Job Sheet 199907

Part No: RBW6405G12131-3G-3

Part Name: Clamp

WORK ORDER NON-CONFORMANCE / ROUTE UPDATE

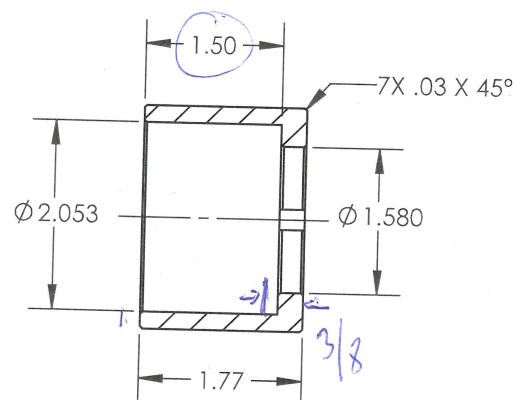
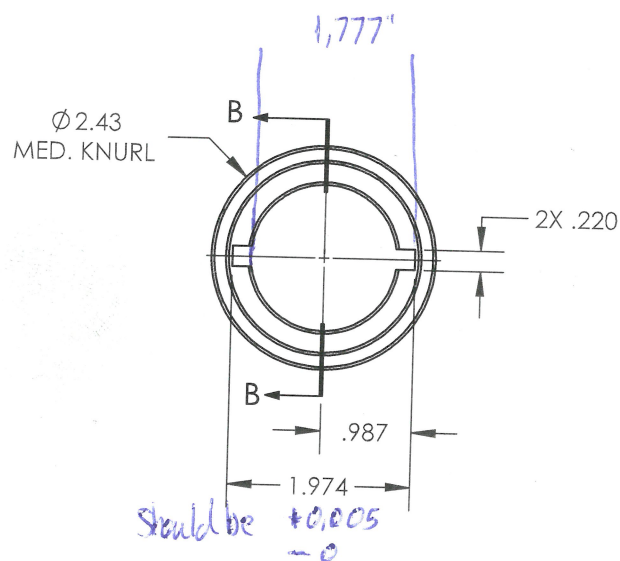
- Small chip on inside of part, due to broaching - One of the Dimension is off tolerance (1.974) is currently 1.985 Acceptable				Acceptable does not effect Fit Form or Function.				Lead hand / Supervisor 19/11/04			
Root Cause				FAULT CATEGORY							
Operator ☐ Manufacturing Process ☒ Equip/Tooling ☐ Handling/Presservation ☐ Material ☐ Product Improvement ☐ Process Improvement ☐ Human Factors ☐				☐ Pressure/Forced ☐ Bending ☐ Crushing ☐ Cracks ☐ Crimp/Kink/Ripple/Wave/Twist ☐ Marks/Chatter ☐ Mislabeled		☐ Contamination ☐ Misaligned/off center ☐ BOM/Route ☒ Broken/Damage/Defect ☐ Incomplete/Unclear Instructions ☐ Drill Holes ☐ Fit/Function		☐ Power Loss/Surge ☐ Folio/Program ☐ Grain Direction ☐ Weld ☐ Wrong Stock Pulled ☐ Out of Sequence ☐ Off-set/Set-up		☐ Positioned Wrong ☐ Outside Tolerance ☐ Drawing ☐ Finish ☐ Part Lost/Missing ☐ Misread	
Other/Details:

Job: 199907		DISPOSITION		DEPARTMENT/PROCESS							
Part No. RBW6405612131-363		Rework ☐ Scrap ☐ Use-as-is ☒		Skid-tube ☐ Machining ☒ Large Fab ☐		Cross tube ☐ Small Fab ☐ Finishing ☐		Eng. (Non-AW) ☐ Prod. Eng. Coord. ☐ Rec/Store/Packaging ☐		Engineering ☐ Water Jet ☐ Supplier ☐ Quality ☐	
Date: 19-11-04		Sequence #: 100		QTY Affected: 4				MRB (QSI042) DAS 51 12/10/31 9-89			
Description Work Order Deviation				Disposition				Completed By 19/11/1
